Technical Memorandum: Review of MW Proposed DSS for Casey Fields South (Employment) and Devon Meadows PSPs

Date: 31/03/2025
Project Number: 2101096, 2102129, 2300328
Project Name: Casey Fields South (Employment) & Devon Meadows PSP drainage strategy consultation
Authors: [REDACTED]
Reviewer: [REDACTED]
Version: 1

Appendix C from the GHD Report

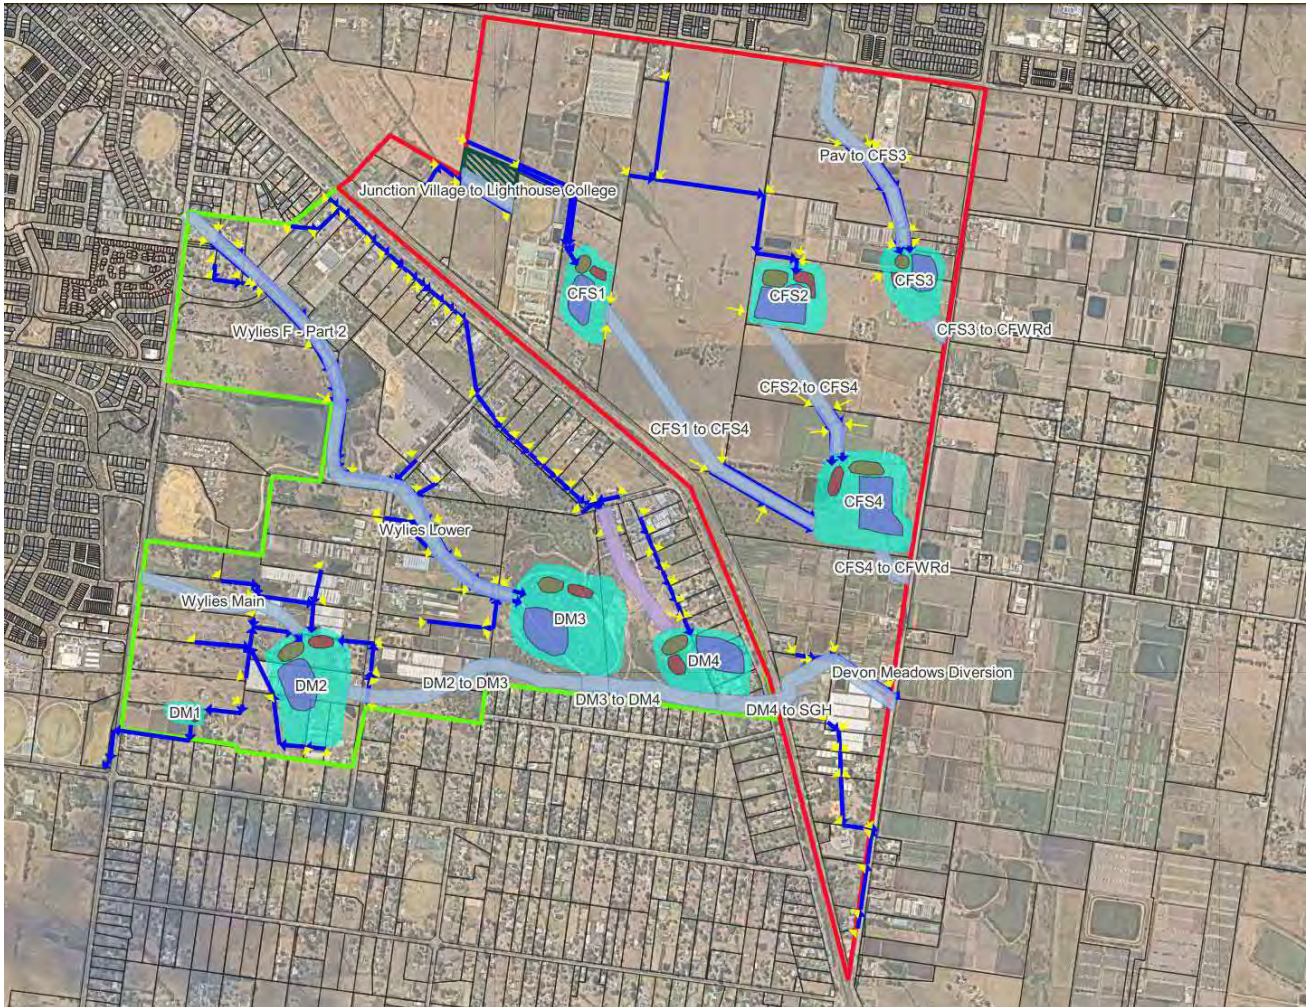
- Under the current proposal from MW and GHD:
 - 4 basins (WLRB) are proposed for Devon Meadows and a further 4 basins on Casey Fields
 - 8 new constructed waterways are required including the proposed diversion channel
 - The key component of the strategy is the diversion channel is to achieve the following:
 - Divert flood flows away from downstream properties to solve flood capacity issues in existing Devon Meadows
 - Prevent increase in volume of water to downstream properties in existing Devon Meadows
 - The strategy terminates at Clyde Five Ways Road with 3 assumed connection points to the downstream channel network.
 - It is noted that the area included in the strategy does not represent the full Clyde Five Ways Rd DSS and Moore Rd DSS.

The current concerns with the proposed strategy are:

- The Diversion Channel
 - The stated purpose of this channel was to protect downstream homes in Devon Meadows from flooding and excessive increases in volumetric discharge.

- While redirecting flows from Devon Meadows would protect these homes from the issues above, its not clear how it solves the issue. Rather it just relocates it as a problem for the landowners on Clyde South to manage until such time as they PSP/DSS can be developed and implemented. Even then, the issue would require additional assets or negotiation with downstream owners to resolve.

Long Section of the Diversion Channel Between DM2 and DM3

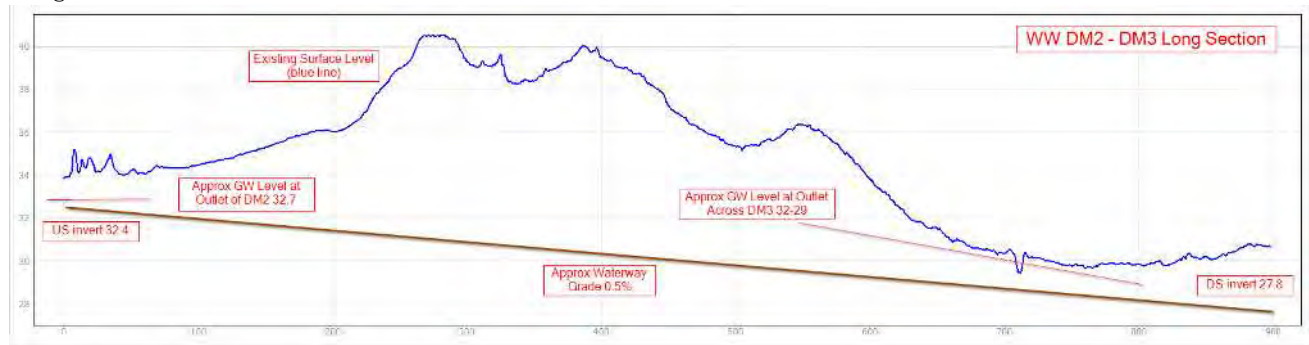
- BW have used the 1m LiDAR and levels summarised in GHDs report to try and understand how the channel works with the terrain and groundwater levels.
 - Preliminary analysis indicates that the diversion channel requires significant cut to achieve the required levels, particularly between basins DM2 and DM3.

- At its deepest, up to 10m of cut will be required which, with the proposed 1:5 batters, could require a reserve width of up to 100m at its widest rather than the 45m shown on GHDs concept plan. This would require a significant volume of earthworks to achieve with the associated significant cost.

- When compared with GHD's groundwater observations, it appears that significant sections of the channel are proposed to be below the groundwater level which raises several key issues:

- If groundwater is allowed to enter the channel, then this is essentially a groundwater extraction and diversion system that will convey an unknown volume of groundwater into Clyde South

- If the channel is lined somehow to exclude groundwater, then this is a significant obstruction to the natural groundwater flow which may cause issues upstream in future Devon Meadows. Its also not clear how this would affect downstream groundwater users (human or environmental)

- Considering the size and scale of the works, the groundwater interaction will complicate the construction methodology further adding cost.
 - The final consideration is that the outfall for this channel is still not negotiated and will require significant culvert upgrades under the South Gippsland Highway and Clyde Five Ways Road. There is also no channel for it to connect to downstream of Clyde Five Ways Road.

the perceived issue, instead just relocating it to a different location. We recommend abandoning the diversion channel proposal and focusing on a different solution to protect homes in Devon Meadows.

Northern Crossing (CFS3 to CFWRd)

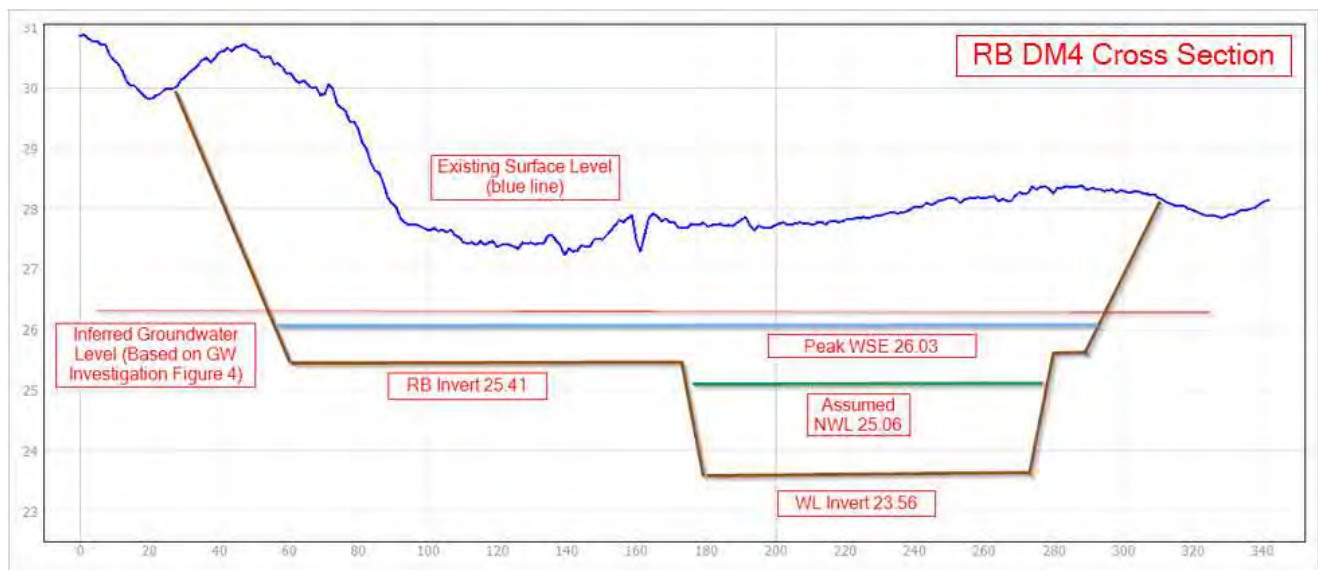
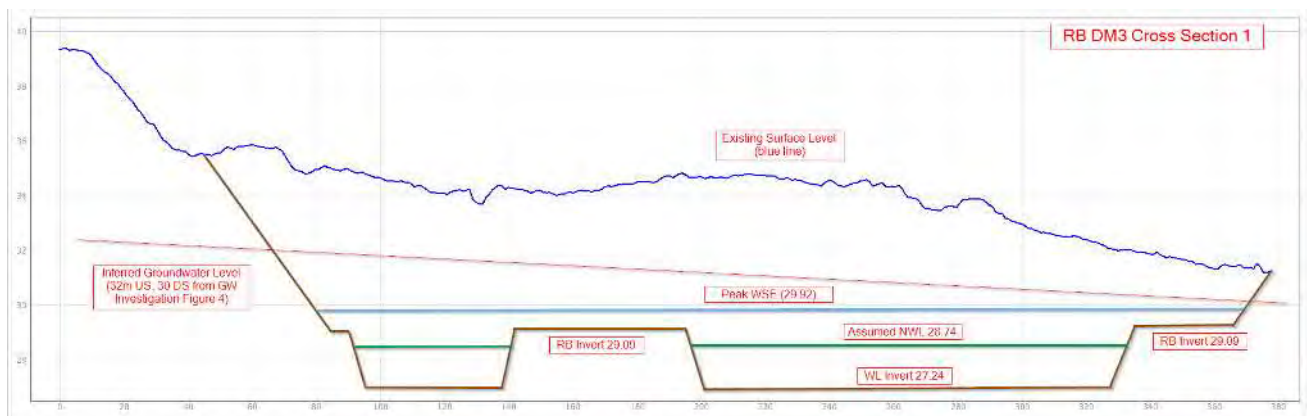
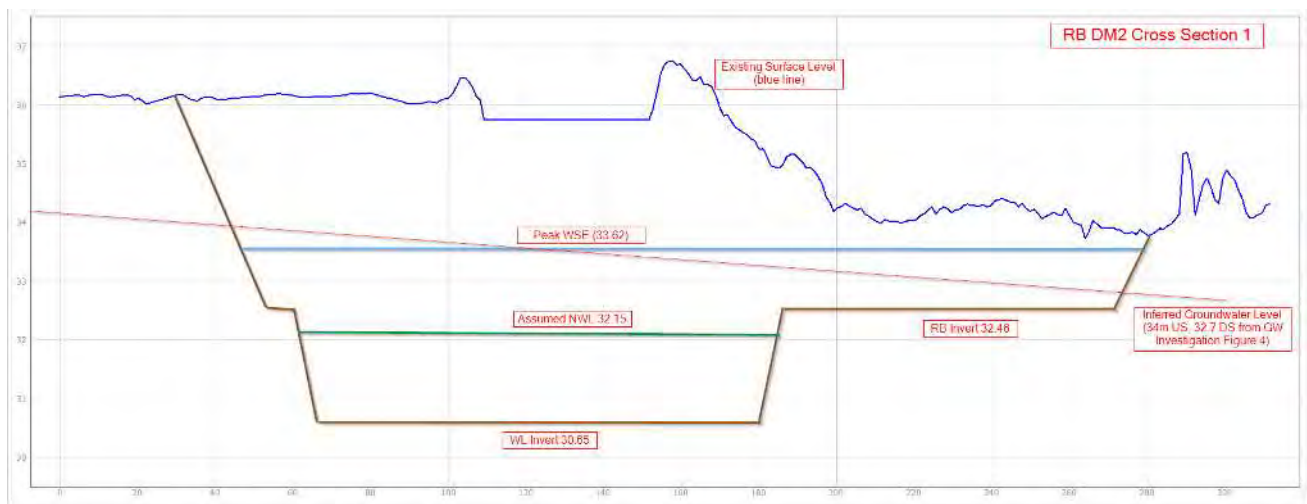
- Connection Points and Impact to Landowners in Clyde South
 - At this time, the proposed strategy relies on 3 connection points (shown in images below)

- These points are characterised by:
 - Roads being only marginally above the surrounding floodplain
 - An absence of any major drainage features, which are at best a small drainage channel and culvert and at worst no drainage feature at all

- The following is unclear:
 - How the proposed connections will work:
 - What will they connect to where no channel exists, will there be a requirement to extend the channel until an appropriate discharge point is reached?

- Is it proposed to lower the channel or raise Clyde Five Ways Rd to construct sufficient culvert crossings?
 - How will these works impact the existing landowners

- Under the current agricultural land use downstream, how will downstream properties manage additional flows from proposed upstream works, especially from increased volumetric discharge from Casey Fields (similar to the Devon Meadows issue) and both volumetric and flood flows from Devon Meadows relocated via the diversion drain.

- Considering that the PSP has not commenced for Clyde South, implementation of any downstream management works could be years away
 - Will interim basins on Casey Fields be implemented to manage these interim issues?

- We would recommend that further analysis be undertaken to address the above questions prior to adoption of the proposed strategy.
